# OPEN HOUSE 2 PUBLIC ENGAGEMENT SUMMARY

FALL 2025

# ADDITIONAL CONCEPTS PRESENTED AT OPEN HOUSE AND NOTES ON FEEDBACK

## CONCEPT A

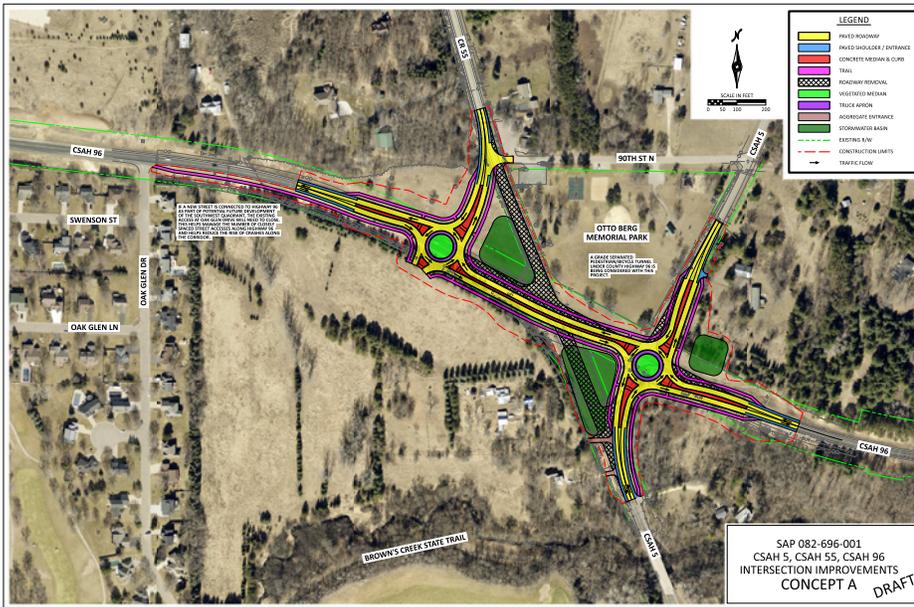
- Seemed to have the most support
- Heard a few concerns regarding delays for folks traveling E-W on 96 or N-S on Norrell
- Appreciation for potential additional park space

## CONCEPT B

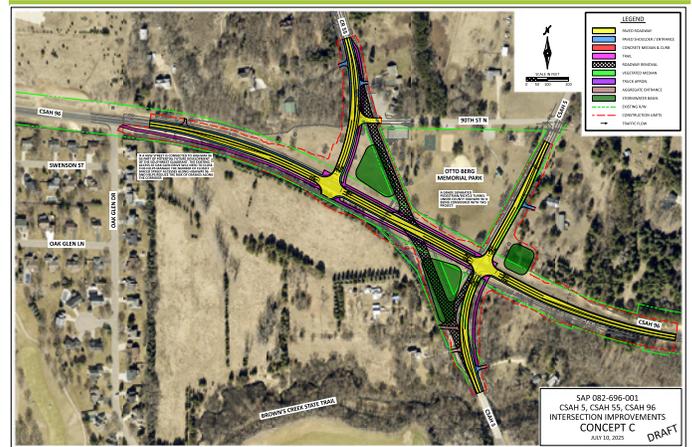
- Heard concerns regarding out of direction travel for residents traveling N-S on Stonebridge, and concerns regarding private property impacts.
- Not a ton of support or discussion for this option.
- Concern about bikes/peds traveling northbound from south leg of 5 to continue north on 5.
- Concern drivers will use 90th St. to get directly to the roundabout to travel EB on 96.

## CONCEPT D

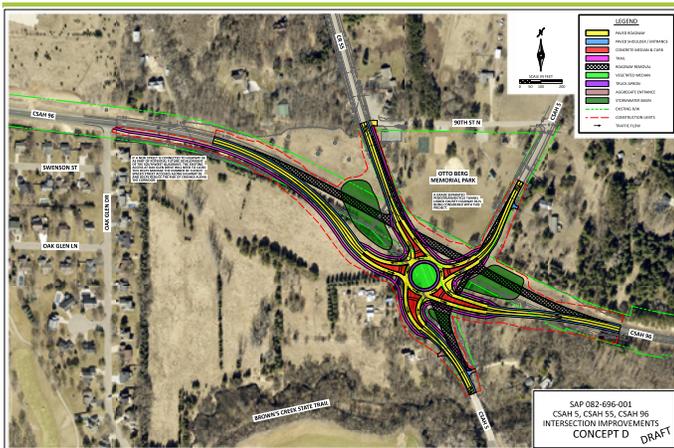
- Fairly mixed - either loved or hated this concept.
- Heard from many about the large footprint of this roundabout and concerns regarding private property impacts.
- Those who didn't support felt it may be confusing and had concerns about bike/ped.
- Those who did support, appreciated only needing to go through a roundabout once.

## CONCEPT E

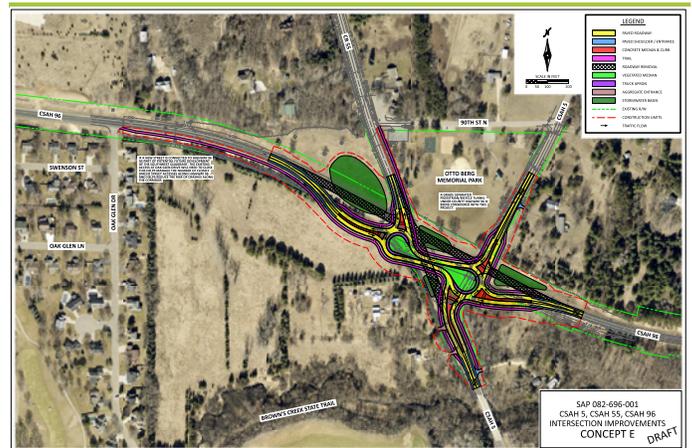
- Positive support of this concept.
- Some residents thought it could be confusing to navigate.
- Neutral or positive comments on this concept once walked through how it works.
- Acknowledgement that potential additional park space is reduced in this concept compared to A.
